Extrusion Simulation Comparison: *After-12/9/03-Meeting Comments (by M. Kostic)*

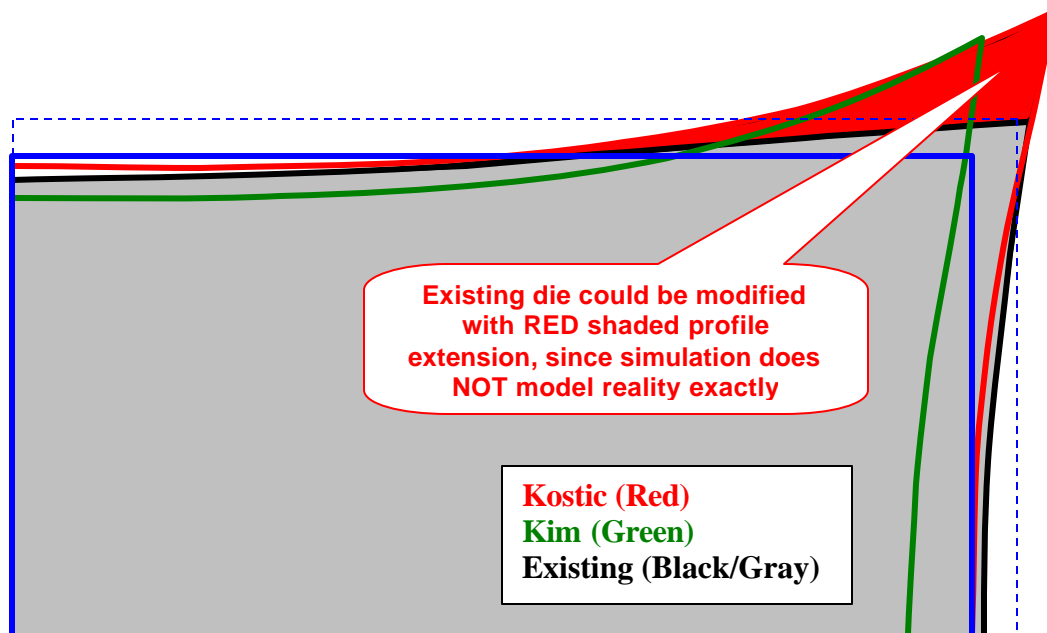
1. The two new die-profiles, by Kim and Kostic's teams, are virtually the same if scaled to 5% increased final profile, as is the usual practice (including existing die) due to shrinkage in calibrator, during cooling and stretching/pulling, see the sketch below:

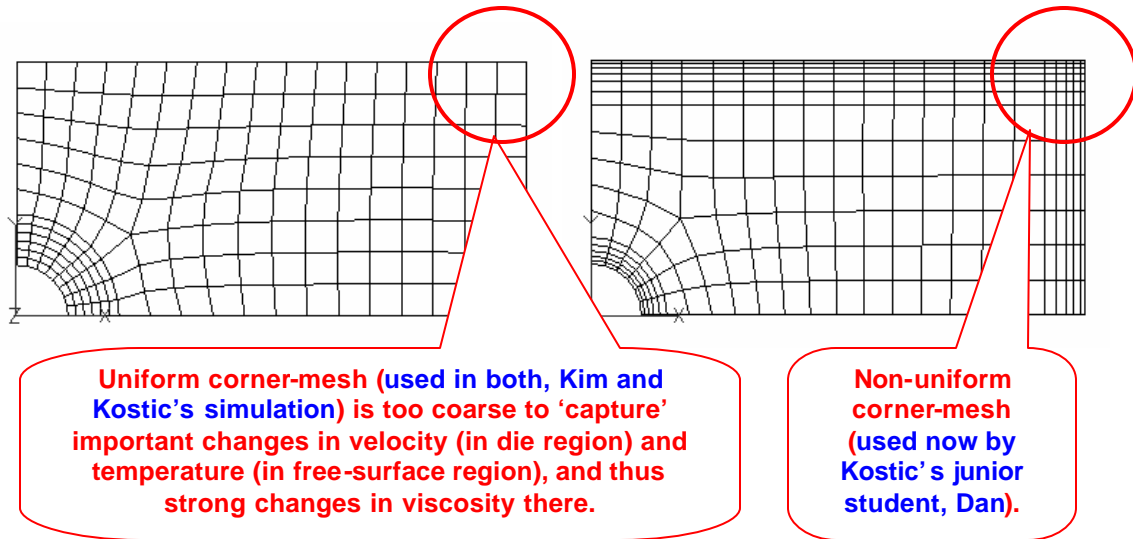
4. It is not surprising that Kim and Kostic teams' simulations are very similar, since they represent almost duplication of the same simulation: similar mesh, material and boundary conditions, using the same commercial software (will be elaborated in another correspondence).
5. The minor differences in the two simulation results are irrelevant since both modeling are approximations: (1) do not include important viscoelastic properties, (2) simplify many boundary conditions (zero radiation heat transfer, zero pressure in inside-surface hole and outlet, etc.), and (3) do not have fine enough non-uniform mesh in the corner area and in the axial flow-direction in vicinity after die-exit, where changes in velocity and temperature field are the largest, see sketch below:
